Technical Service Bulletin (TSB)
Noise From Steering Wheel While Turning

REFERENCE:	TSB: 08-251-24 GROUP: 08 - Electrical	Date:	December 10, 2024	REVISION:	–
VEHICLES AFFECTED:	2023 - 2024 (B1) Jeep Renegade 2023 - 2024 (H1) Jeep Commander 2023 - 2024 (M1) Jeep Compass This bulletin applies to vehicles built on or after December 28, 2023 (MDH 1228XX) and on or before November 14, 2024 (MDH 1114XX).			MARKET APPLICABILITY:	
				<input checked="" type="checkbox"/> NA	<input type="checkbox"/> MEA
				<input checked="" type="checkbox"/> SA	<input type="checkbox"/> IAP
				<input type="checkbox"/> EE	<input type="checkbox"/> CH
CUSTOMER SYMPTOM:	Customers may comment on the following: <ul style="list-style-type: none"> Noise when turning the steering wheel. 				
CAUSE:	Wire harness interference

Fig. 1
Steering Wheel Harness

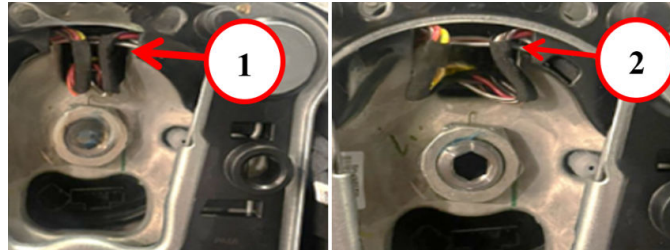
2. Is a noise heard coming from the steering wheel when turning?
 - YES>>> Proceed to [Step 3](#).
 - NO>>> This bulletin has been completed. Use Inspection LOP (XX-XX-XX-XX) to close the active RSU.
3. Disconnect and isolate the negative battery cable.
4. Remove the Driver Air Bag (DAB). Refer to the detailed service procedures available in DealerCONNECT/Service Library under: Service Info> 4110A11 - Volante - remocao/recolocacao para versoes com air bag.
5. Correct the position of the wire harness [Fig. 1](#).

1 - Incorrectly Positioned Wire Harness
2 - Correctly Positioned Wire Harness

6. Turn the steering wheel full left and right to confirm the noise is eliminated.
7. Install the DAB. Refer to the detailed service procedures available in DealerCONNECT/Service Library under: Service Info> 4110A11 - Volante - remocao/recolocacao para versoes com air bag.
8. Connect the negative battery cable.
